GRE-AFS Working Paper No. 4-5  
(4th session of the GRE Informal  
Group on AFS, 15-17 July 2003)

PROPOSAL FOR DRAFT AMENDMENTS TO REGULATION No. 48

(Installation of lighting and light-signalling devices)

Transmitted by the Expert from the Working Party "Brussels 1952" (GTB)

*Apparent surfaces of lighting units 1 through 11 of an AFS (example)*

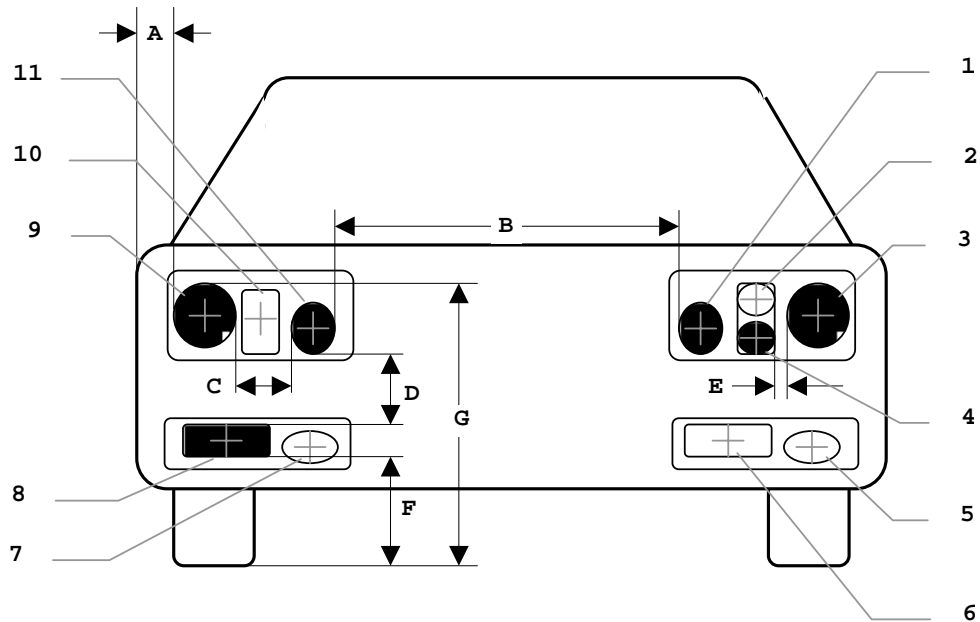
6.20.4.1.1. *Two symmetrically placed lighting units shall be positioned at a height in compliance with the requirements of the relevant paragraphs 6.1.4. and 6.2.4.,*

*where "Two symmetrically placed lighting units" shall be understood to be two lighting units, one on each side of the vehicle, positioned such that the (geometric) centres of gravity of their apparent surfaces are at the same height and at the same distance from the vehicle's longitudinal median plane within a tolerance of 50 mm, each; their light emitting surfaces, illuminating surfaces, and light outputs, however, may differ.*

6.20.4.1.2. *Additional lighting units, if any, on either side of the vehicle shall be positioned at a distance not exceeding 140 mm 7/ in horizontal direction (E in the figure) and 400 mm in vertical direction above or below (D in the figure) from the nearest lighting unit;*

6.20.4.1.3. *None of the additional lighting units described in paragraph 6.20.4.1.2. above shall be positioned lower than 250 mm (F in the figure) nor higher than [ 950 /1200 /1500 ] mm (G in the figure) above the ground;*

*the outer edge of the apparent surface of at least one lighting unit on each side of the vehicle shall not be more than 400 mm from the extreme outer edge of the vehicle (A in the figure); and,*

*the distance between the inner edges of the apparent surfaces of the lighting units on the right and left hand side of the vehicle (B in the figure) shall be not less than 600 mm, or, except for category M<sub>1</sub> and N<sub>1</sub> vehicles not less than 400 mm when the overall width of the vehicle is less than 1300 mm.*
